Changes to Trees

The proposed quantity of trees and species have changed slightly since the original planning submission. The required level of BNG is still exceeded, refer to Envirotech report for full details.

New Proposal To Pedestrian Entrance

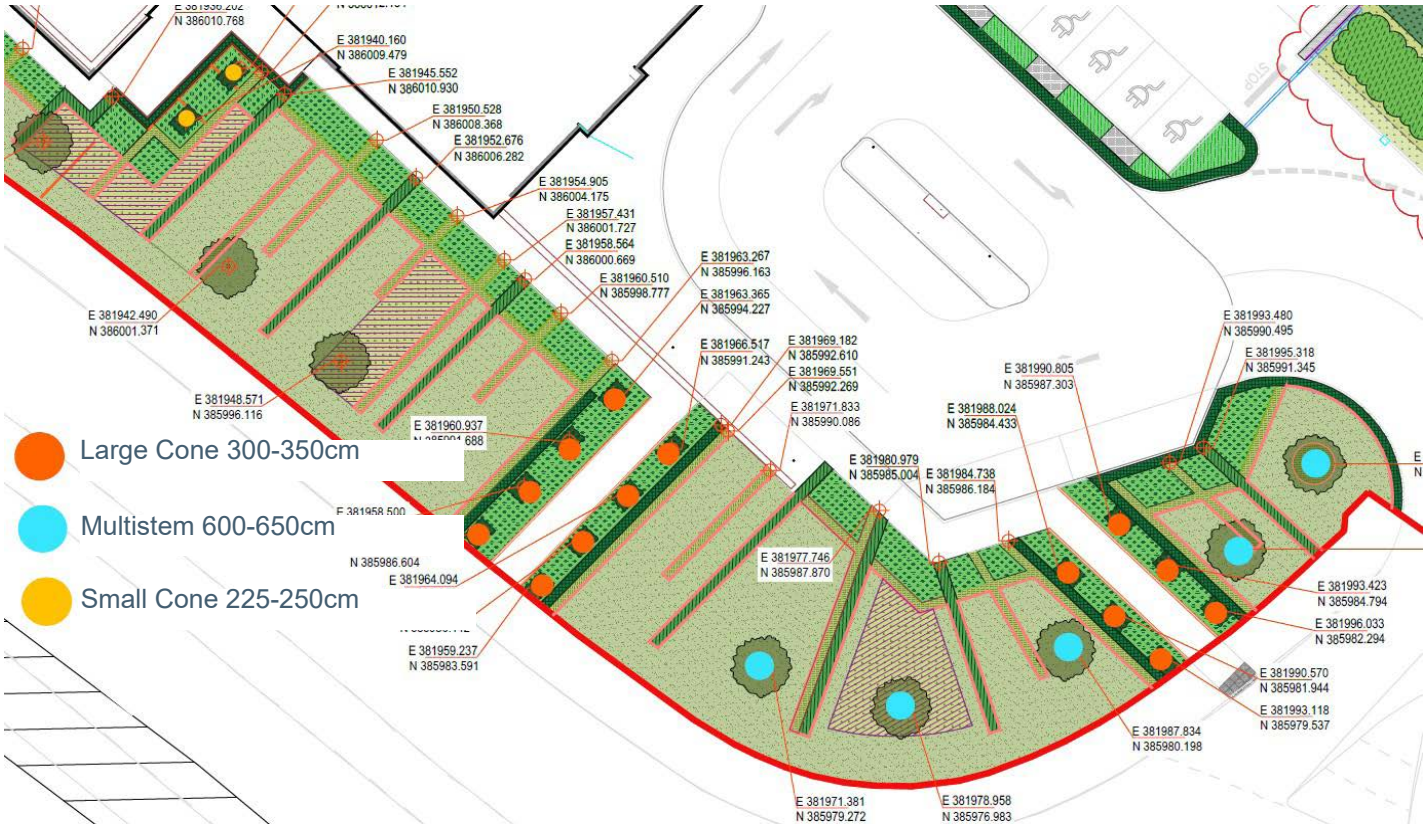
Original Proposal To Pedestrian Entrance

Quercus ilex (Holm Oak) Specification: Pleached

Specification no longer suitable as UK stocks depleted and no longer available for import due to the Oak Processionary Moth. Plants cannot be imported into UK in areas designated free of pest. In addition acorns are produced which does not meet MAG requirements.

Large cone specification
300-350cm

Small cone specification 225-250cm

Multistem specification
600-650cm

Northern White Cedar - Thuja occidentalis ‘Smaragd’

- Evergreen
- Non-fruiting
- Striking multistemform not widely seen in UK
- Strong pyramidal shape (relects others trees used in scheme)
- Fulfils the design intent to have topiary specimens
- Fully hardy
- Creates space for underplanting as specified in planting plan
